## TOLEDO - LUCAS COUNTY PLAN COMMISSIONS

REF: PUD25-0002

SUBJECT: Amendment to Planned Unit Development, Originally Granted by Ord. 150-25, for a New Library and Storage Building

The Toledo City Plan Commission recommends that the Toledo City Council **approve** PUD25-0002, a request for Amendment to a Planned Unit Development, originally granted by Ord. 150-25, for a new library and storage building at 3027 Alexis Road to Toledo City Council, for the following **two (2) reasons**:

# LANDSCAPE PLAN

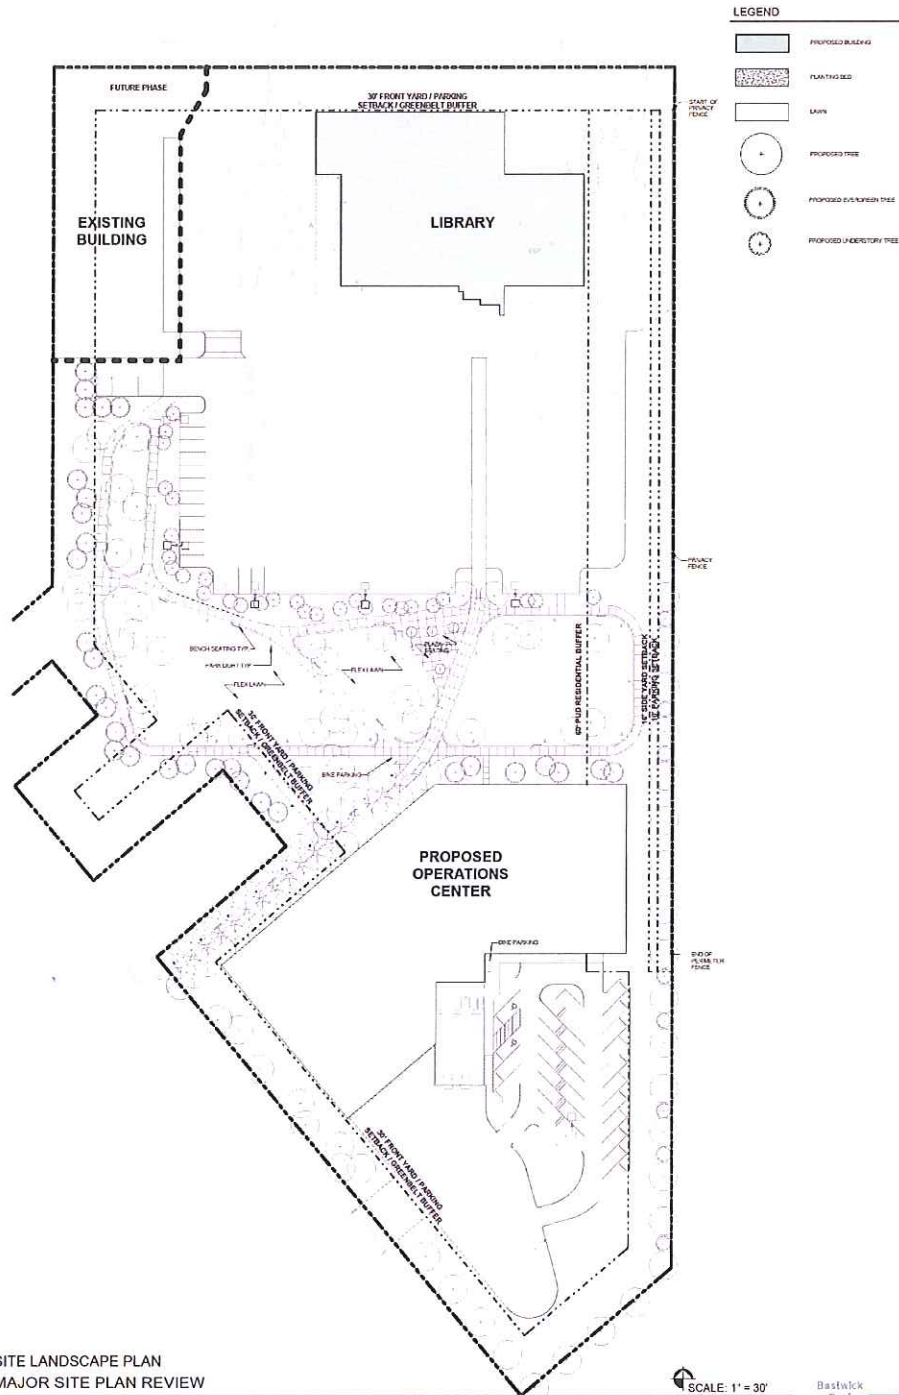
In addition to open space requirements, PUD's are required to meet landscape and screening requirements of TMC§1108. A minimum thirty-foot (30') wide frontage greenbelt along Tremainsville Road is required per TMC§1108.0202. This greenbelt must contain at least one (1) tree for every thirty-feet (30') of frontage. Nineteen (19) trees are required along Tremainsville Road. The tree planting plan depicts fifteen (15) trees along Tremainsville Road. An additional four (4) trees shall be provided as a condition of approval. Additionally, the frontage greenbelt shall include a solid evergreen hedge as a parking area is proposed to be developed in the front of the property. The shrub planting plan does not show the required evergreen hedge; therefore this requirement shall be required and listed as a condition of approval.

Buffer and screening requirements are also required per TMC§1108.0203. A Type A Buffer is required along a portion of the east property line as the site is zoned CR – Regional Commercial and the abutting property is zoned RS6 – Single-Family Residential. A six-foot (6') high cedar privacy fence is proposed along this area and therefore four (4) canopy trees and fifteen (15) shrubs per 100 linear feet are required. A Type B Buffer is required along the other portion of the east property line as the abutting property is zoned CO – Office Commercial. A fence is not proposed in this location and is not required. The Type B Buffer also requires four (4) canopy trees and fifteen (15) shrubs per 100 linear feet. In total nineteen (19) canopy trees and seventy-one (71) shrubs are required along the eastern property line. The tree planting plan depicts fifteen (15) canopy trees and eight (8) understory trees for an equivalent of twenty (20) canopy trees. The shrub planting plan also depicts twenty-five (25) shrubs. The submitted tree planting plan meets the buffer and screening requirements along the east property line; however, the shrub planting plan does not. An additional forty-six (46) shrubs shall be provided on a revised landscape plan and listed as a condition of approval.

Both interior and perimeter parking lot landscaping is required per TMC§1108.0204. For interior parking lot landscaping, two (2) canopy trees and six (6) shrubs are required to be installed in interior landscape areas for each ten (10) parking spaces. A total of six (6) trees and eighteen (18) shrubs are required in the interior of the parking lot based on the proposed thirty (30) parking spaces. There is no landscaping provided for the parking lot. The required trees and shrubs shall be included on a revised landscape plan and listed as a condition of approval.

Parking lot perimeter landscaping must be installed along any parking lot area adjacent to a street, place, or driveway, or is visible from an immediately adjacent property. For perimeter parking lot landscaping, one (1) canopy tree for each thirty linear feet (30') and a continuous shrub hedge to screen headlights from surrounding areas is required. In this case, the frontage greenbelt will count towards perimeter landscaping requirements along Tremainsville Road as noted above for the frontage greenbelt. The proposed trees in the Type B Buffer along the east property line will count towards the perimeter landscaping requirements; however, a solid evergreen hedge is required along the parking area to shield headlights from adjacent properties. The solid evergreen hedge requirement shall be depicted on a revised landscape plan and listed as a condition of approval.

In addition to the other landscape requirements for buffer areas, frontage greenbelts, and landscaping for parking lots, TMC§1108.0205(B) requires the following: one 2-inch caliper tree for every 1,000 square feet of building coverage, foundation plantings along all portions of the building that are visible from the public rights-of-way, and landscaping at all major building entrances. Based on the total building square footage, seventy-six (76) trees are required. Foundation plantings are also required along the west and northwest sides of the proposed operations center. There are in excess of seventy-six (76) trees provided in the interior of the site. In addition, there are trees noted along the northwest side of the proposed operations center; however, there are no shrubs provided as foundation plantings. A mix of trees, shrubs and groundcover shall be provided on a revised landscape plan with foundation plantings along the west and northwest sides of the building as well as at the main entrance, which is included as a condition of approval.

- a. Per TMC§1108.0202, a minimum thirty-foot-wide frontage greenbelt along public rights-of-way is required that contains at least one (1) tree for every thirty-feet (30') of frontage. Nineteen (19) trees are required along Tremainsville Road and the tree planting plan depicts fifteen (15). Additionally, the frontage greenbelt shall include a solid evergreen hedge, which is not provided. **Not acceptable as depicted. An additional four (4) trees and a solid evergreen hedge shall be provided.**

- b. Per TMC§1108.0203, a Type A Buffer is required along a portion of the east property line and a Type B Buffer is required along the other portion of the east property line. These two (2) buffers require a total nineteen (19) canopy trees and seventy-one (71) shrubs along the eastern property line. The tree planting plan depicts fifteen (15) canopy trees and eight (8) understory trees for an equivalent of twenty (20) canopy trees. The shrub planting plan also depicts twenty-five (25) shrubs. **Not acceptable as depicted. An additional forty-six (46) shrubs shall be provided.**

- c. Per TMC§1108.0204, two (2) canopy trees and six (6) shrubs are required to be installed in interior landscape areas in a parking lot for each ten (10) parking spaces. A total of six (6) trees and eighteen (18) shrubs are required in the interior of the parking lot based on the proposed thirty (30) parking spaces. There is no landscaping provided for the parking lot. **Not acceptable as depicted. The required six (6) trees and eighteen (18) shrubs shall be provided.**

- d. Perimeter landscaping must be installed along the parking lot area adjacent to a street, place or driveway, or which is visible from an adjacent property. The frontage greenbelt counts toward perimeter landscaping requirements along Tremainsville Road. The proposed trees in the Type B Buffer along the east property line count towards the perimeter landscaping requirements; however, a solid evergreen hedge is required along the parking area to shield headlights from adjacent properties. **Not acceptable as submitted. A continuous shrub hedge shall be provided along the east side of the parking lot.**

- e. Per TMC§1108.0205(B), one 2-inch caliper tree for every 1,000 square feet of building coverage, foundation plantings along all portions of the building that are visible from the public rights-of-way, and landscaping at all major building entrances are required. There are in excess of the required seventy-six (76) trees provided in the interior of the site; however, foundation plantings and landscaping at the major building entrances are not provided. **Not acceptable as depicted. A mix of trees, shrubs and groundcover shall be provided as foundation plantings along the west and northwest sides of the building and landscaping provided at the main entrance.**
